## Chapter 10 - Biodiversity.

Where Epyc further threatens a threatened species (and I'm not talking about lifestylers)

Below is the layout of the Kalbilli turbine group and the Glossy Black-Cockatoo habitat. The Glossy Black habitat is cross-hatched.

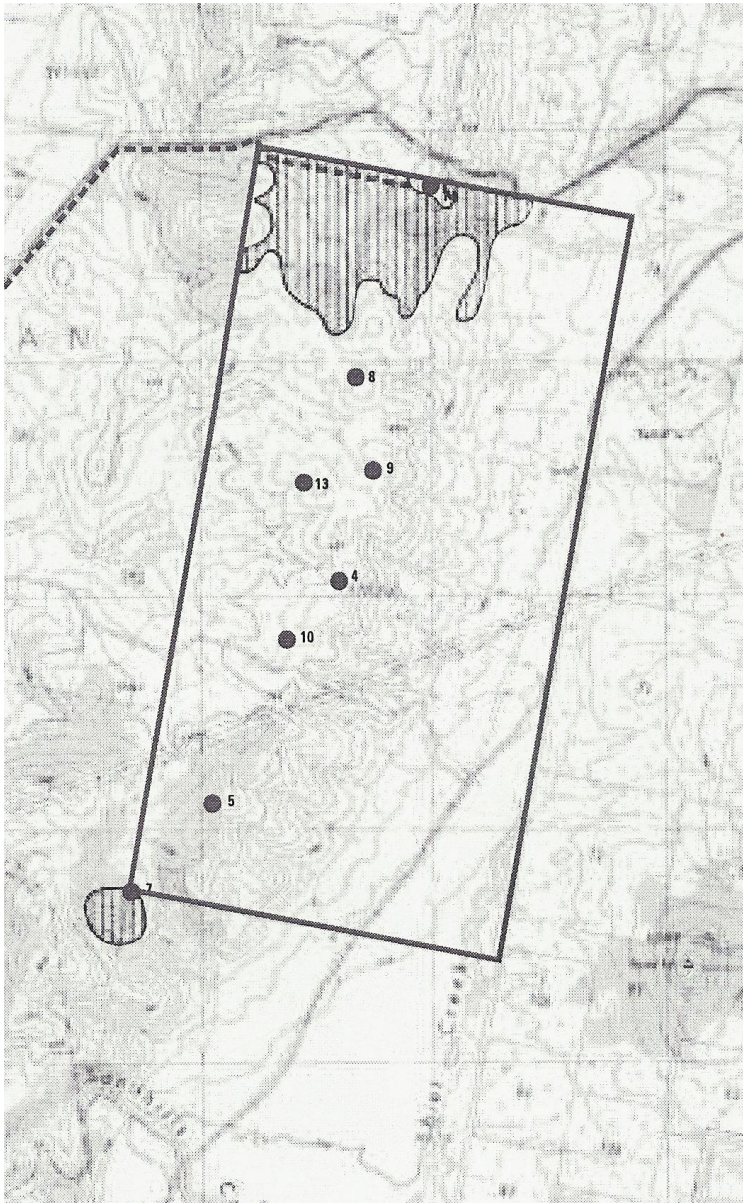
Kalbilli Turbine 4 was to be approximately 4.2 kilometres west of the proposed Jupiter turbine 87. ie. well within feeding range.

Below is a section of Fig 6.7a (Biodiversity Assessment, Part 2). All turbines shown are in the E3 environmental zone. Glossy Black-cockatoo habitat is cross hatched. The large Crown land parcel is directly below the Glossy Black-cockatoo habitat.

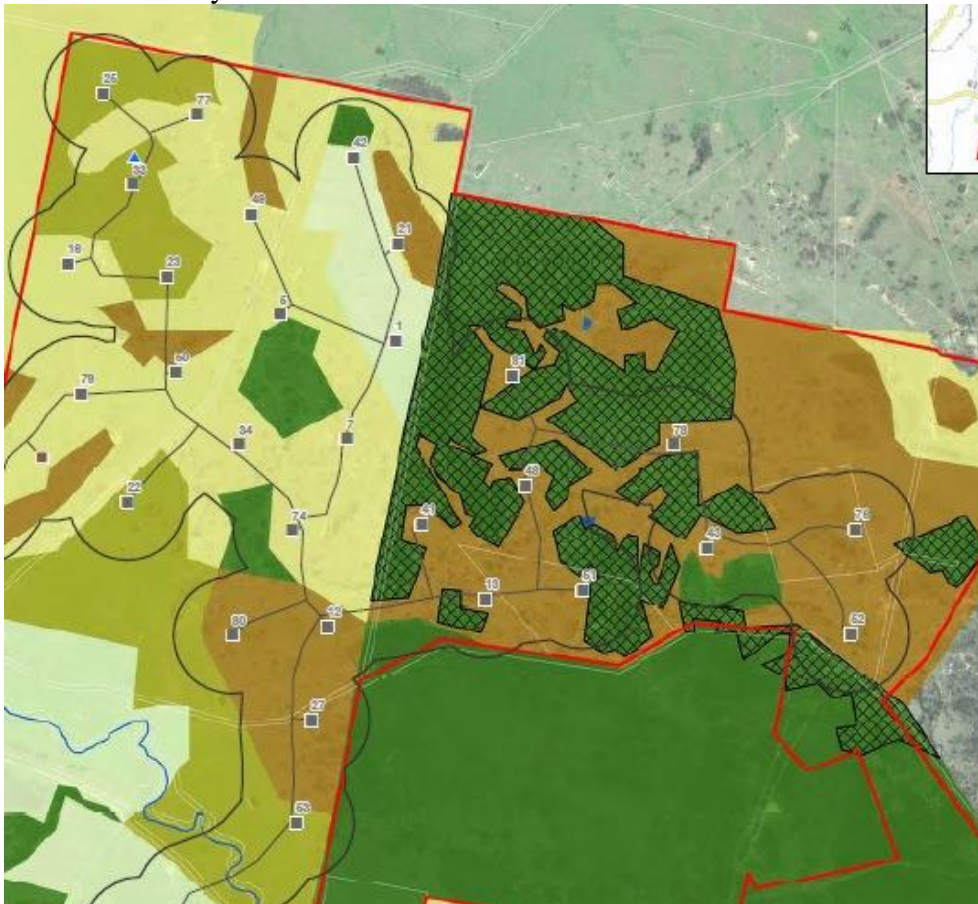
Somewhere between 80 and 427 hectares of Glossy Black-cockatoo habitat are within the northern section of the project area.<sup>2</sup>

EIS surveys found this area actively used by feeding Glossy Black-cockatoos

That habitat contains 9 turbines.

All of that habitat is within the E3 zone.

The northern section of the wind farm surrounds a large parcel (approximately 200 hectares)<sup>3</sup> of Crown bushland. That area is likely to be a nesting area (ERM didn't bother to find out, although they agree it is a "possibility"<sup>4</sup>). This area is also wholly within the E3 zone. As you can see, flight paths between the feeding habitat and the Crown land section will be through turbines.

The flight path to and from the Kalbilli feeding habitat will be through turbines.

So here we have a significant environmental impact in a zone where the Goulburn Mulwaree LEP prohibits wind farms. Is it reasonable to assume that one of the key reasons that the area is zoned E3 is because of the presence of a large “prime” area of habitat for an endangered species?

The Department must prohibit turbines in the whole of the E3 zone.
